Version 2

Capless Fuel Shutter Set (Mis-Fuel Inhibit Device) Is Frozen

Supersedes 18-012, dated February 22, 2018, to revise the sections highlighted in **yellow**.

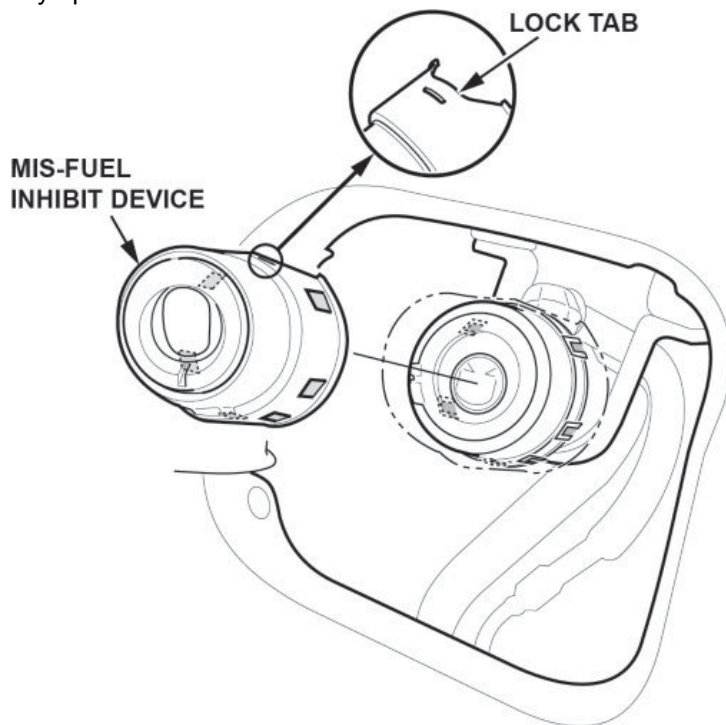
1. Remove the mis-fuel inhibit device by breaking the 6 lock tabs.

2. Pry up the lock tab and remove the mis-fuel inhibit device.

3. Install the new mis-fuel inhibit device.

Civic 4-door

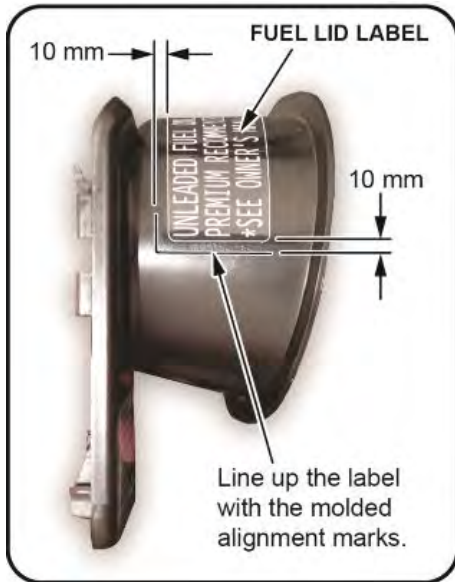
1. **On Si models only:** Apply the fuel lid label to the new fuel lid cover as shown.

Make sure the new fuel lid cover is clean and grease-free, especially on the surface where the label will be applied.

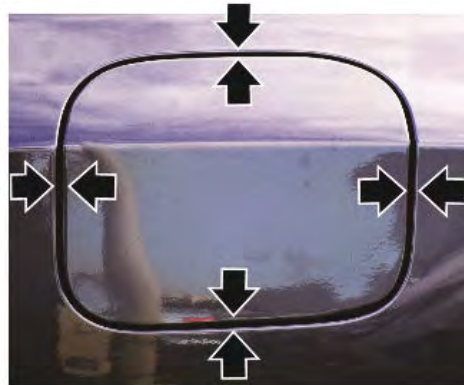
2. Align the hooks on the top edge of the fuel lid cover to the fuel door.

3. Press the bottom of the fuel lid cover to the fuel door until both locking tabs click. This indicates the fuel lid cover is securely and correctly installed.

Civic 2-door

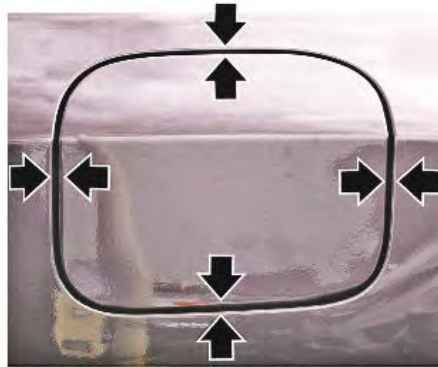
2. Align the hook on the right side edge of the fuel lid cover to the fuel door.

3. Press the left of the fuel lid cover to the fuel door until both locking tabs click. This indicates the fuel lid cover is securely and correctly installed.
